SUBJECT: R.E. Ginna Nuclear Power Plant
Docket No. 50-244

Supplementary Response to Generic Letter 2004-02, "Potential Impact of Debris Blockage on Emergency Recirculation During Design Basis Accidents at Pressurized-Water Reactors"

REGNPP GL 2004-02 RAI RESPONSE

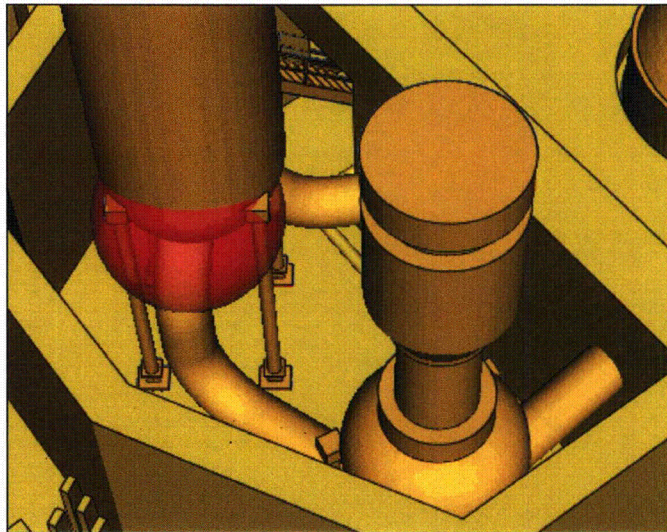
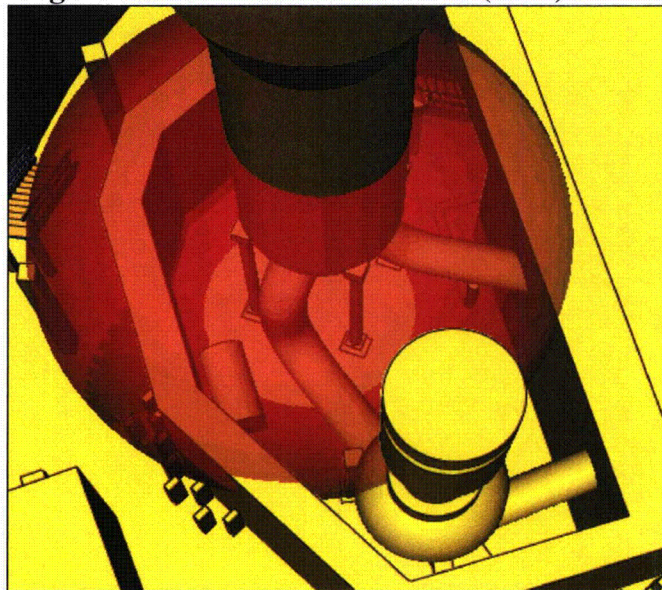
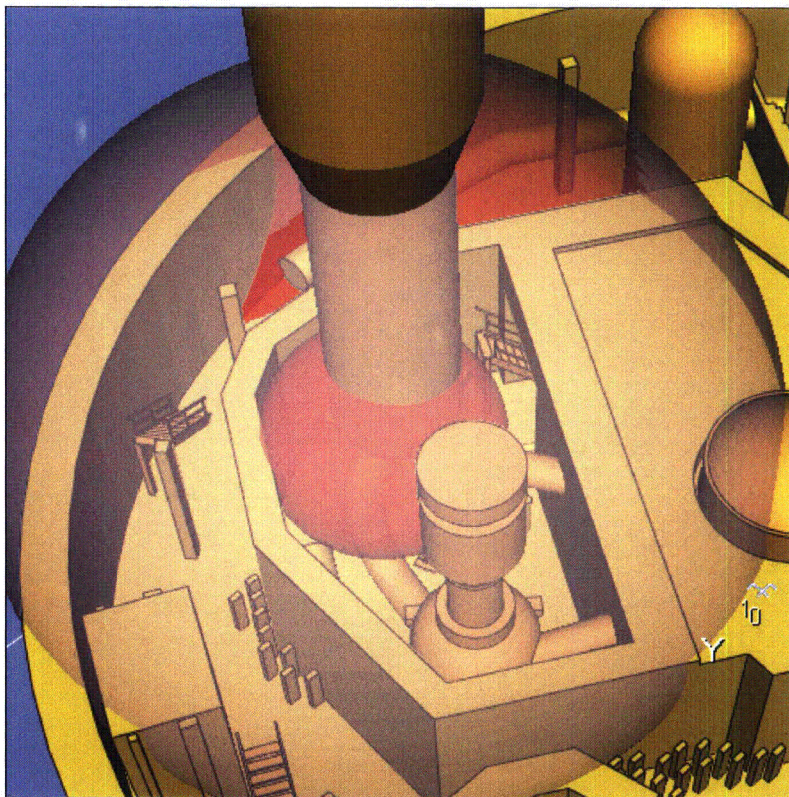
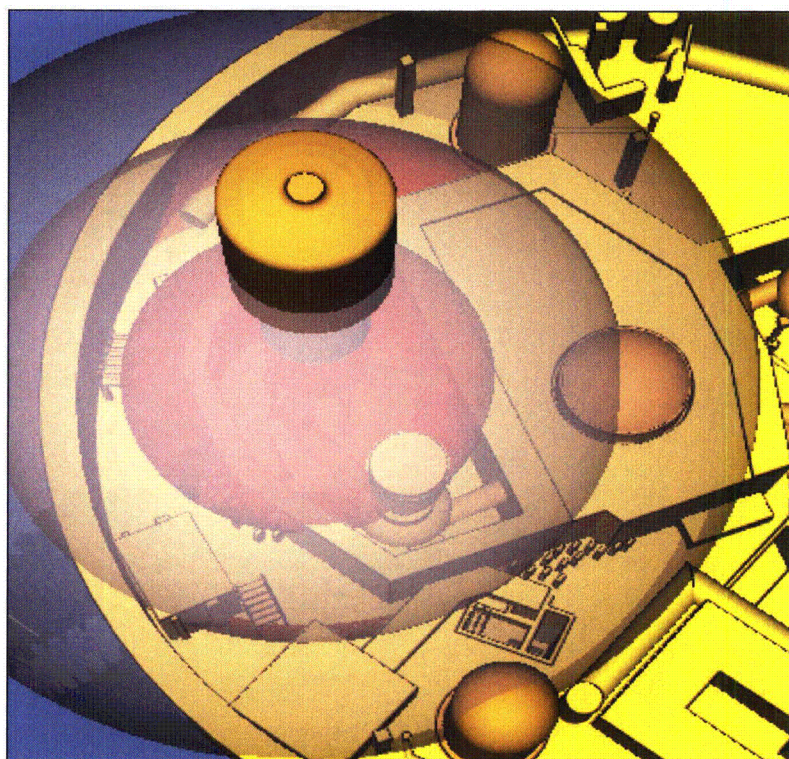
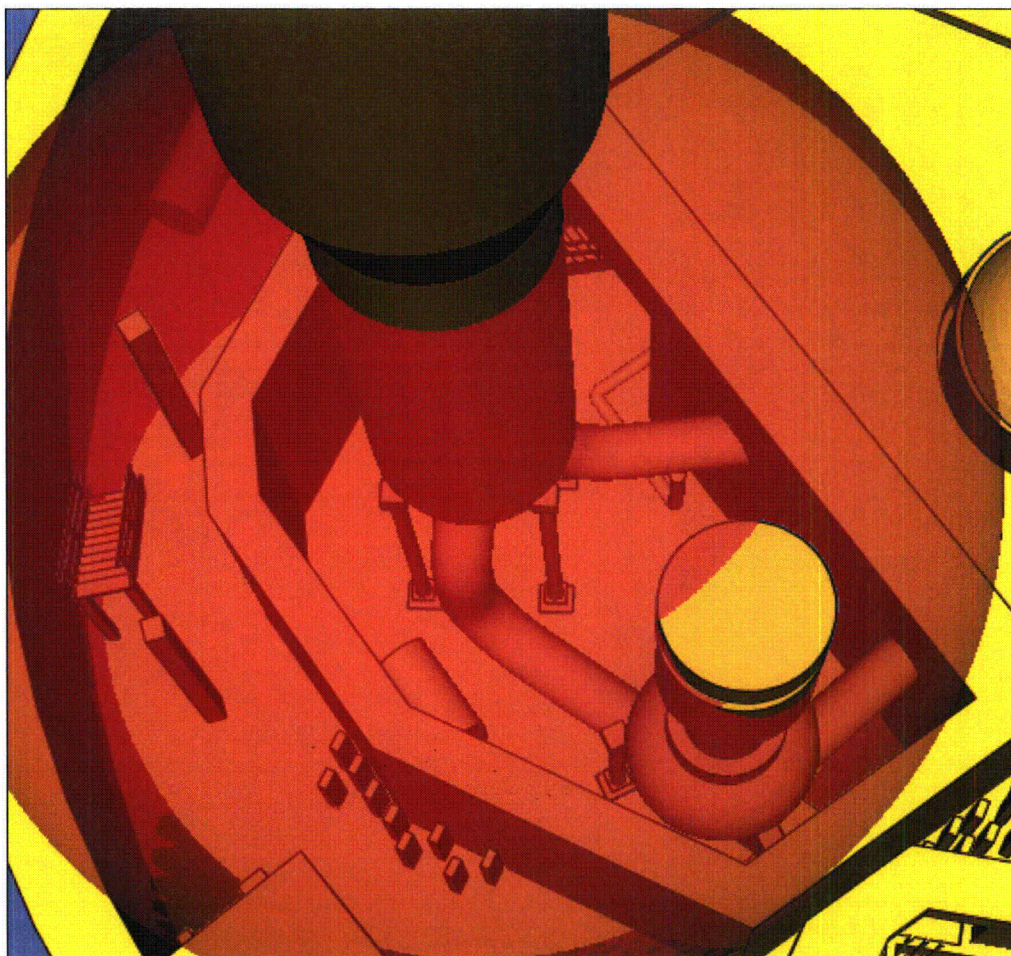
- 2. Provide destruction zone of influences and the basis for the zone of influences for each applicable debris constituent.*
- 3. Identify if destruction testing was conducted to determine zone of influences. If such testing has not been previously submitted to the NRC for review or information, describe the test procedure and results with reference to the test report(s).*

According to the debris spreadsheet, the RMI in Compartment A is located on the bottom of the steam generator (EMS01A) and on the reactor coolant pump. As shown in Figure 3.b.2.1, the postulated break at the base of the steam generator would destroy most of the RMI on the steam generator, but would not affect the RMI on the pump. A break could be postulated next to the pump, which would destroy a larger quantity of RMI. However, given the fact that RMI has been shown to be less significant in terms of head loss than other types of insulation debris, the worst break location is relatively insensitive to the quantity of RMI generated.

Two sub-zones of destruction were defined for Temp-Mat™. Small quantities of Temp-Mat™ are located on the elbows of many of the lines insulated with Cal-Sil. However, the largest quantities of Temp-Mat™ in Compartment A are located on the hot leg and intermediate leg piping. The size distribution for Temp-Mat™ is dependant on the debris source's distance from the break location. Ginna's calculations show a total quantity of 58.8 ft³ of Temp-Mat™ is destroyed for this break case.

As shown in Figure 3.b.2.4 above, three sub-zones of destruction were defined for Thermal-Wrap™. Within Compartment A, the Thermal-Wrap™ (denoted in the debris spreadsheet simply as Transco) is located on the SG blowdown lines, the primary loop piping, and the steam generator body. Using the CAD model, the surface area of the steam generator body was estimated to be 2,157 ft². The thickness of the Thermal-Wrap™ on the body is 4 inches [vi]. Therefore, the total quantity on the steam generator is approximately 719 ft³. The first sub-zone would extend 18 ft up from the base of the steam generator encompassing approximately 195 ft³ of Thermal-Wrap™. The second sub-zone would extend up 31 ft from the base of the steam generator encompassing an additional 161 ft³ of Thermal-Wrap™. The third sub-zone would extend 44 ft up from the base of the steam generator encompassing an additional 192 ft³ of Thermal-Wrap™. Since the third sub-zone does not extend all the way to the top of the steam generator, 171 ft³ of the Thermal-Wrap™ on the steam generator would not be destroyed.

Figure 3.c.1.1 – RMI debris size distribution

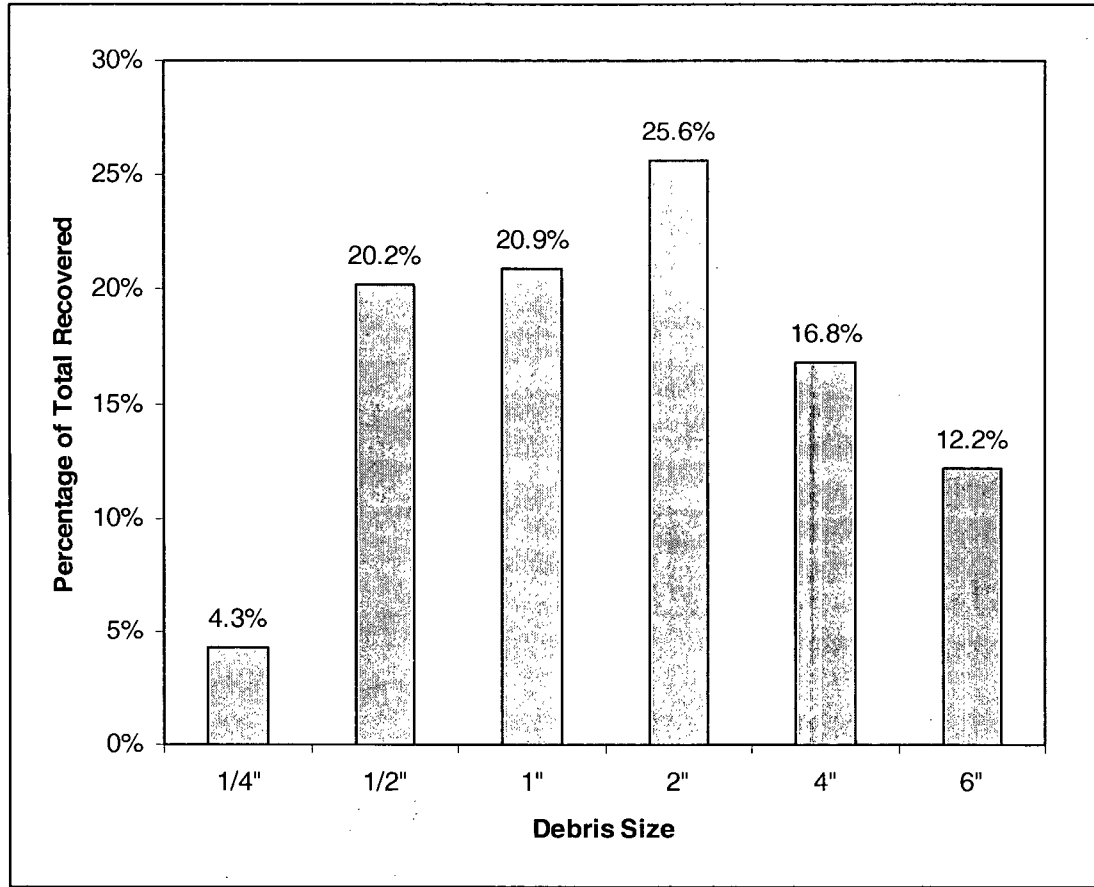
- 1. Provide the assumed size distribution for each type of debris.*
- 2. Provide bulk densities (i.e., including voids between the fibers/particles) and material densities (i.e., the density of the microscopic fibers/particles themselves) for fibrous and particulate debris.*
- 3. Provide assumed specific surface areas for fibrous and particulate debris.*
- 4. Provide the technical basis for any debris characterization assumptions that deviate from NRC-approved guidance.*

Figure 3.c.1.1 shows the debris size distribution summarizing the results of 2-phase jet tests of MirrorTM RMI. This plot shows that 71% of the RMI was destroyed in ¼-inch to 2-inch pieces, and 29% was destroyed in 4-inch to 6-inch pieces. Based on this data, the NEI 04-07 methodology (Section 3.4.3.3.2) recommends using a size distribution of 75% small fines and 25% large pieces, where small fines are defined as anything less than 4 inches. This size distribution was assumed to apply to all types of RMI, and was adopted in this analysis for the Transco RMI at Ginna.

Figure 3.e.1.1 – Generic Debris Transport Logic Tree

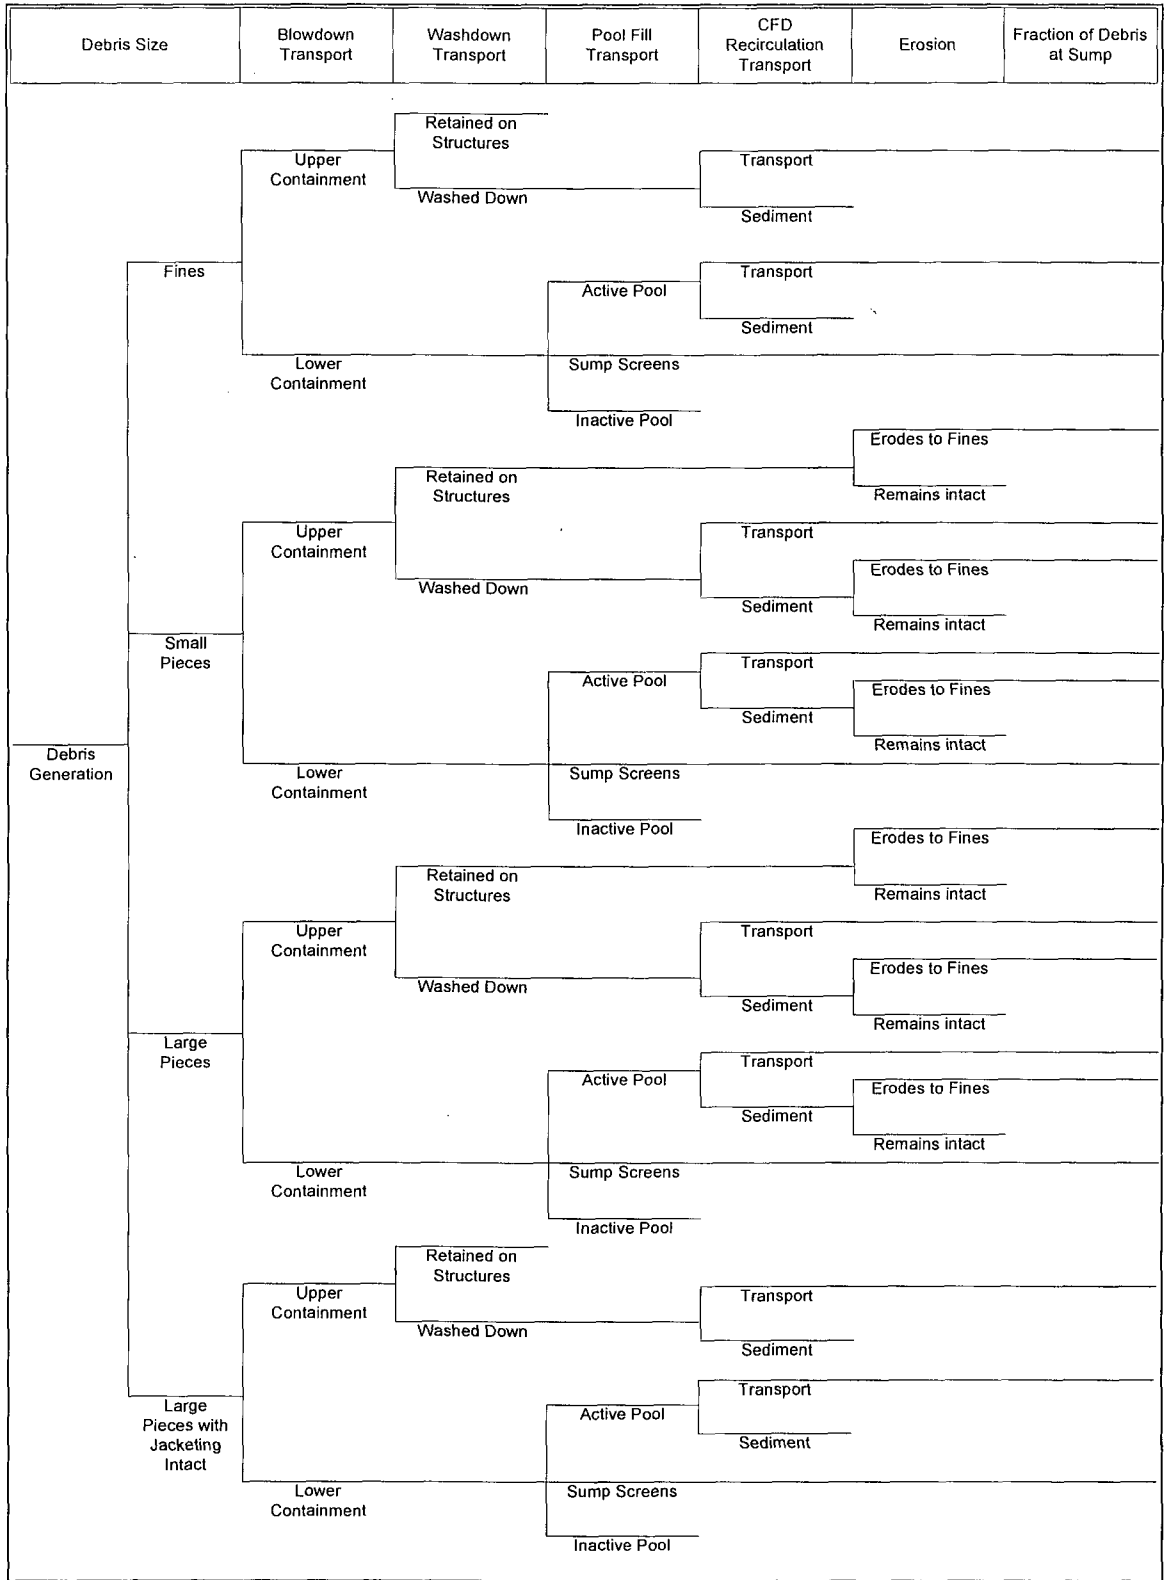
- 1. Describe the methodology used to analyze debris transport during the blowdown, washdown, pool-fill-up, and recirculation phases of an accident.*
- 2. Provide the technical basis for assumptions and methods used in the analysis that deviate from the approved guidance.*
- 3. Identify any computational fluid dynamics codes used to compute debris transport fractions during recirculation and summarize the methodology, modeling assumptions, and results.*
- 4. Provide a summary of, and supporting basis for, any credit taken for debris interceptors.*
- 5. State whether fine debris was assumed to settle and provide basis for any settling credited.*
- 6. Provide the calculated debris transport fractions and the total quantities of each type of debris transported to the strainers.*

that can be more easily analyzed. A generic transport logic tree for a four-category size distribution is shown in Figure 3.e.1.1.

The logic tree approach can be used for each type of debris. The size distribution and characterization for the specific debris types comes from the debris generation calculation. The logic tree shown in Figure 3.e.1.1 is somewhat different than the baseline logic tree provided in the GR. This departure was made to add conservatism regarding the transport of large pieces, erosion of small and large pieces, the potential for wash down debris to enter the pool after inactive areas have been filled, and the direct transport of debris to the sump strainer during pool fill-up. Also, the generic logic tree was expanded to account for a more refined debris size distribution.

Figure 3.f.1.0.2 Containment Spray

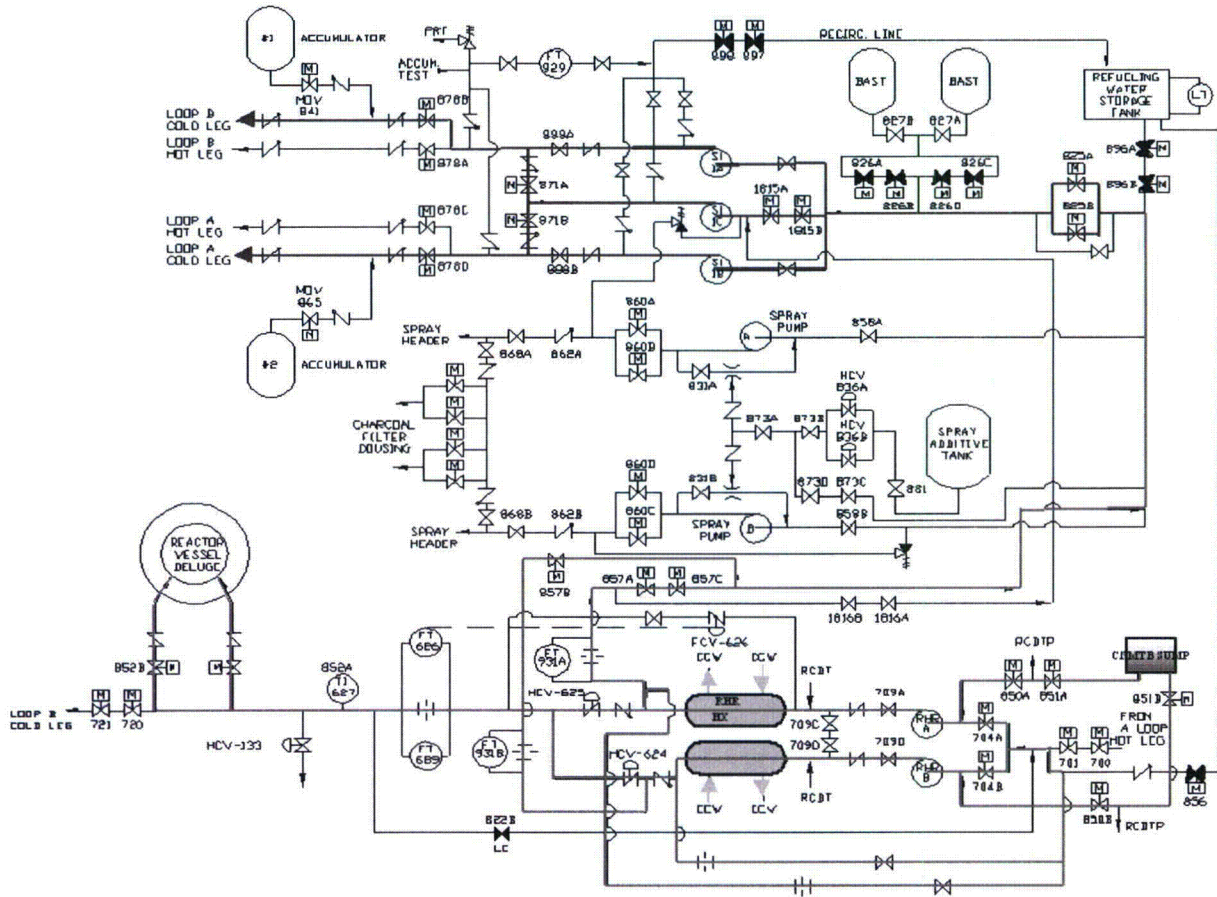
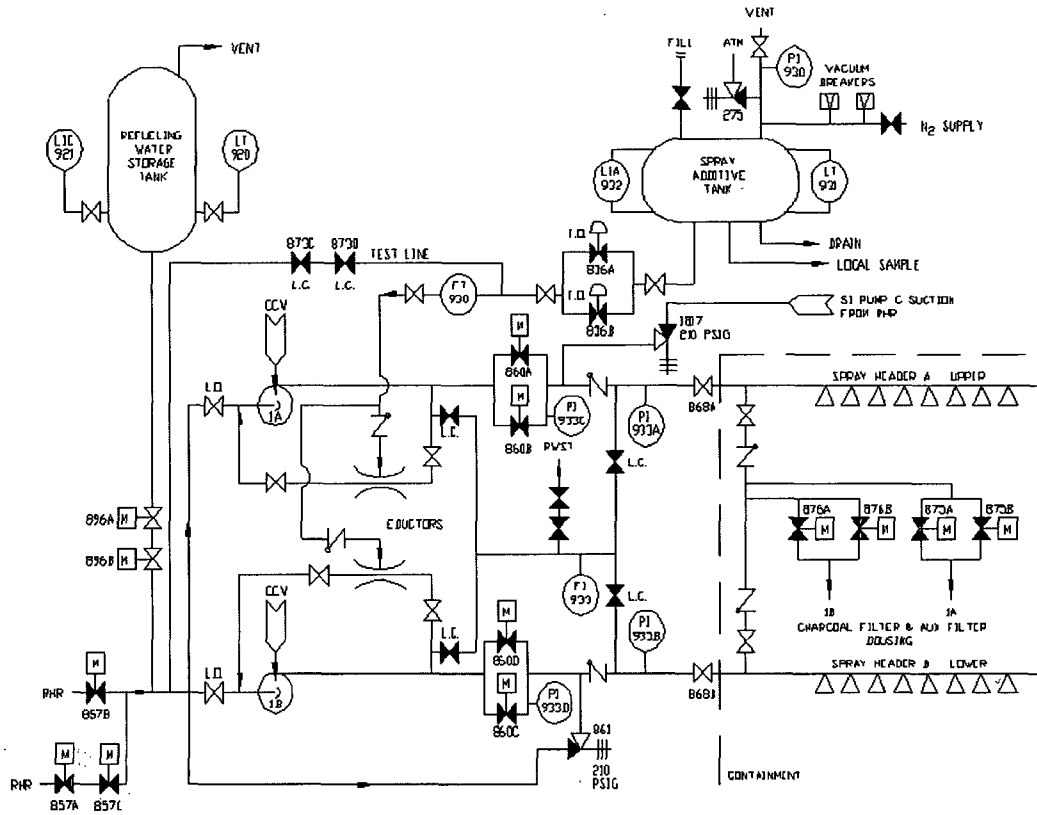
1. *Provide a schematic diagram of the emergency core cooling system (ECCS) and containment spray systems (CSS).*
2. *Provide the minimum submergence of the strainer under small-break loss-of-coolant accident (SBLOCA) and large-break loss-of-coolant accident (LBLOCA) conditions.*

Ginna Station utilizes a group of systems known collectively as Engineered Safety Feature (ESF) systems to mitigate the effects of design basis accidents. The systems of concern can be broken into two subgroups: Emergency Core Cooling Systems (ECCS), which provide borated injection water to the Reactor Coolant System in the event of primary system breaks, and Containment Spray (CS) System, which cools and condenses the steam released by high energy line breaks inside the containment structure. Initially, borated water from the Refueling Water Storage Tank (RWST) will be injected into the RCS and sprayed into containment to mitigate the effects of the accident. When an adequate inventory of water has been established in containment, the ESF systems will be re-aligned to take suction from the containment sump to maintain ECCS functions for the duration of the event. The CS system is not required in this latter mode except under beyond-design-basis conditions. The ECCS and CS are represented in Figure 3.f.1.0.1 and Figure 3.f.1.0.2 below.
